Addendum 94 – UN Regulation No. 95

Revision 3 - Amendment 1

05 series of amendments – Date of entry into force: 9 June 2021

Uniform provisions concerning the approval of vehicles with regard to the protection of the occupants in the event of a lateral collision

Figure 3
Jointed Test Finger

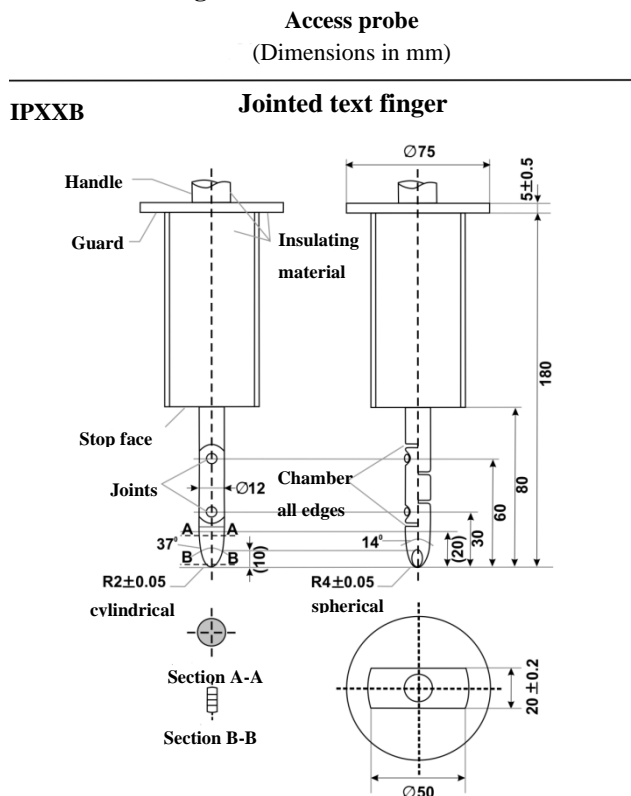
The jointed test finger described in Figure 3 shall be inserted into any gaps or openings of the physical protection with a test force of $10 \text{ N} \pm 10$ per cent for electrical safety assessment. If partial or full penetration into the physical protection by the jointed test finger occurs, the jointed test finger shall be placed in every position as specified below.

Starting from the straight position, both joints of the test finger shall be rotated progressively through an angle of up to 90 degrees with respect to the axis of the adjoining section of the finger and shall be placed in every possible position.

Both joints shall permit movement in the same plane and the same direction through an angle of 90° with a 0 to +10° tolerance.

The requirements of paragraph 5.3.7.1.3. of this Regulation are met if the jointed test finger described in Figure 3, is unable to contact high voltage live parts.

Figure 4

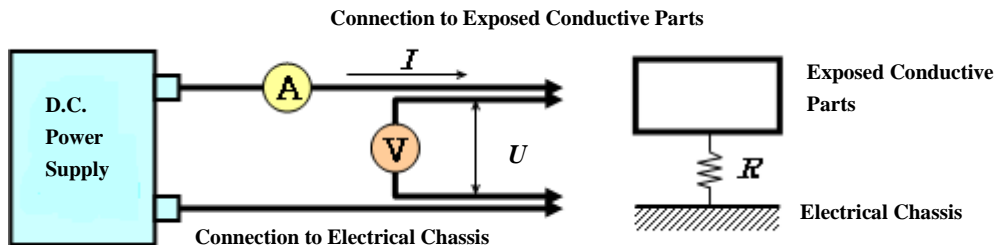
The DC power supply, voltmeter and ammeter are connected to the measuring points (Typically, electrical chassis and electro conductive enclosure/electrical protection barrier).

The voltage of the DC power supply is adjusted so that the current flow becomes at least 0.2 A.

The current "I" and the voltage "U" are measured.

The resistance "R" is calculated according to the following formula:

The resistance R shall be less than 0.1 Ω.

Note: If lead wires are used for voltage and current measurement, each lead wire shall be independently connected to the electrical protection barrier/enclosure/electrical chassis. Terminal can be common for voltage measurement and current measurement.

Figure 5
Measurement of U_1'

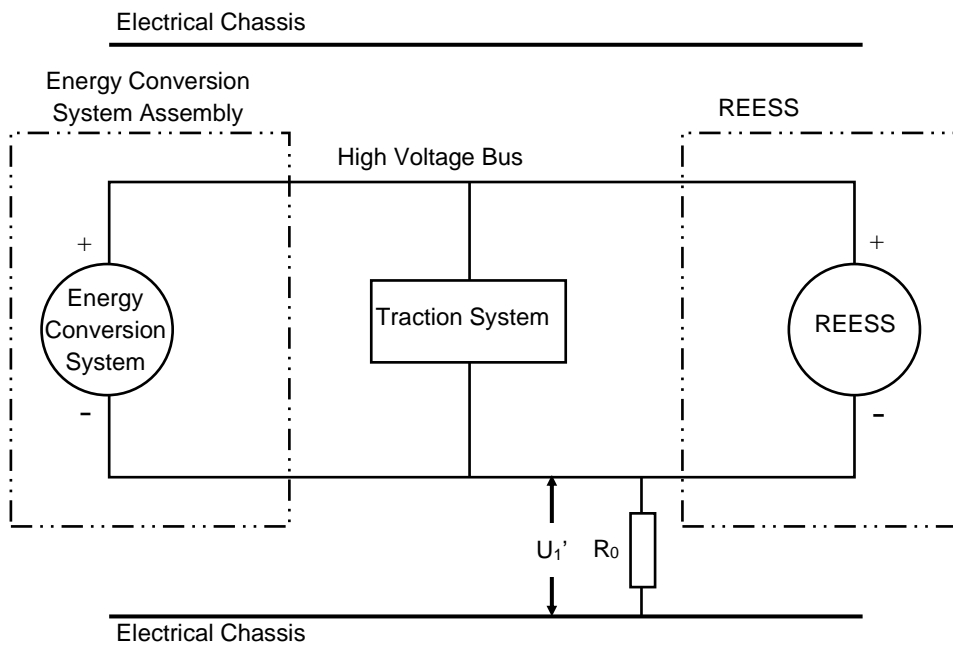
If U_1 is greater than or equal to U_2 , a standard known resistance (R_o) is inserted between the negative side of the high voltage bus and the electrical chassis. With R_o installed, the voltage (U_1') between the negative side of the high voltage bus and the electrical chassis is measured (see Figure 5).

The electrical isolation (R_i) is calculated according to the following formula:

Figure 6
Measurement of U_2'

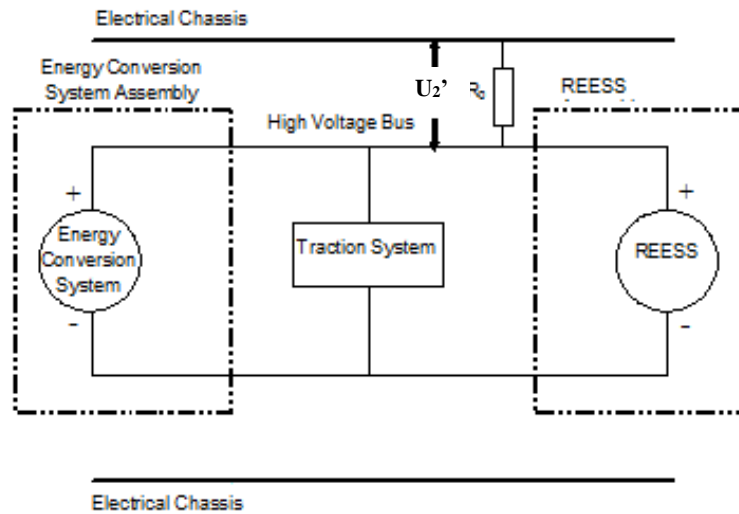
If U_2 is greater than U_1 , insert a standard known resistance (R_o) between the positive side of the high voltage bus and the electrical chassis. With R_o installed, measure the voltage (U_2') between the positive side of the high voltage bus and the electrical chassis (see Figure 6 below). The electrical isolation (R_i) is calculated according to the following formula:

$$R_i = R_o * U_b * (1/U_2' - 1/U_2)$$
